WASTE ISOLATION PILOT PLANT

SPALLINGS

PEER REVIEW REPORT

October 2003

Figure 3-3: Failure and Fluidization

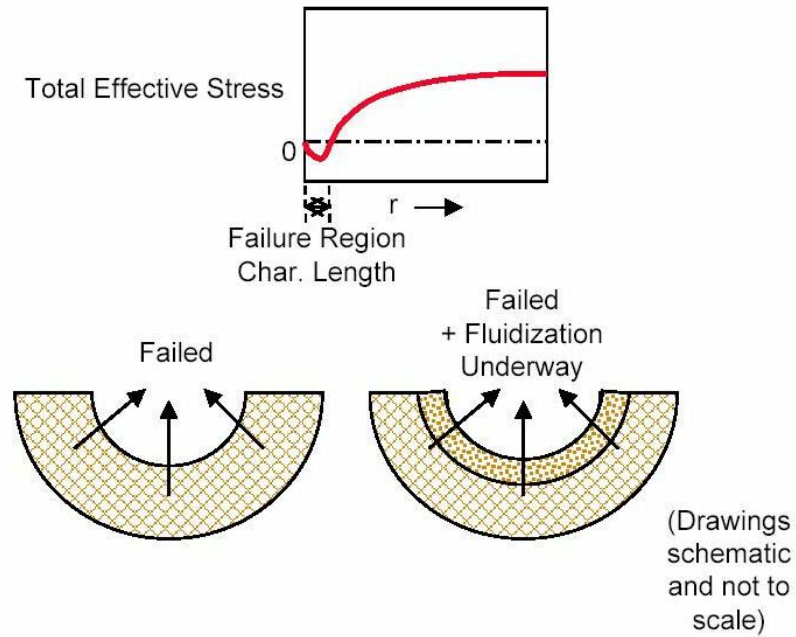
In the numerical implementation, a characteristic length L_c , that covers several grids (or nodal points) is used to determine the failure zone of the medium. Note that L_{fz} shown in Figure 3.3 is the length of tensile failure zone which may consist of several characteristic lengths. When the average effective radial tensile stress over the characteristic length exceeds the failure stress T_o , the particles inside the length are assumed failed. Therefore, the failure zone shown in Fig. 3.3 may contain several characteristic lengths. The characteristic length is an important parameter in determining the size of failure zone and the volume of spalling release. The effect of characteristic length on spalling volume will be discussed in a later section.

The SNL spalling model does not calculate the particle size of the disintegrated material. It assumes that the material disintegrates to particles of the surrogated material (to be discussed later). Since the particle size of the surrogated material is small, the Panel considers that it is an acceptable and conservative approach for simplifying the problem.

Figure 3-4: DDZ in front of the drill bit

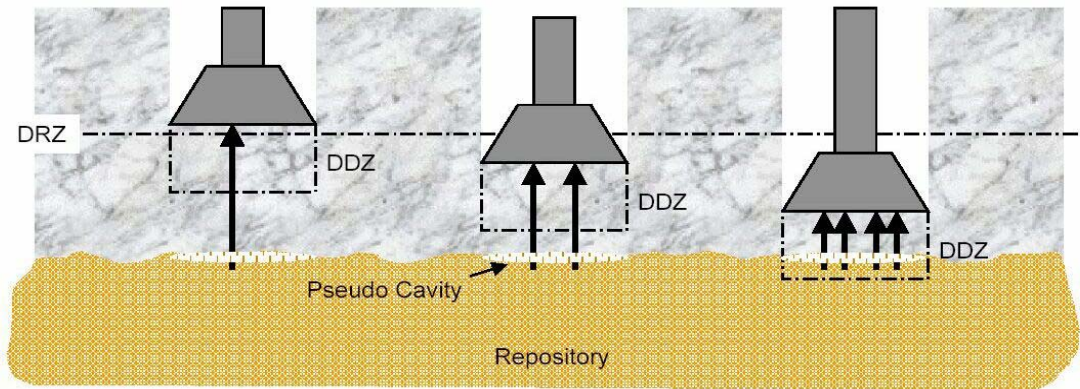
Although the DDZ is not mentioned in SAND97-1369, it was presented during the peer review. As mentioned in a previous section, it has been assumed that the action of the drill bit produces a damaged zone (DDZ) in front of the advancing bit. The DDZ serves as a transition zone between the borehole and the repository. It allows the gas pressure at the bottom of the mud column to buildup smoothly reaching the reservoir value (i.e., no pressure discontinuity as the bit penetrates through the interface). In the numerical calculation, a small air cavity is placed at the interface of mud and repository to ensure the continuity condition between these two regions.

The DDZ is assumed to have a higher permeability than the host rock (halite) and the DRZ (Damaged Rock Zone) but a lower permeability than the repository. As the drilling bit approaches the interface between the host rock and the repository, the lower boundary of the DDZ will contact the repository first. At this time, the gas trapped in the repository would flow upward through the DDZ and interact with the mud column. Figure 3.4 shows drilling damaged zone in front of the bit.
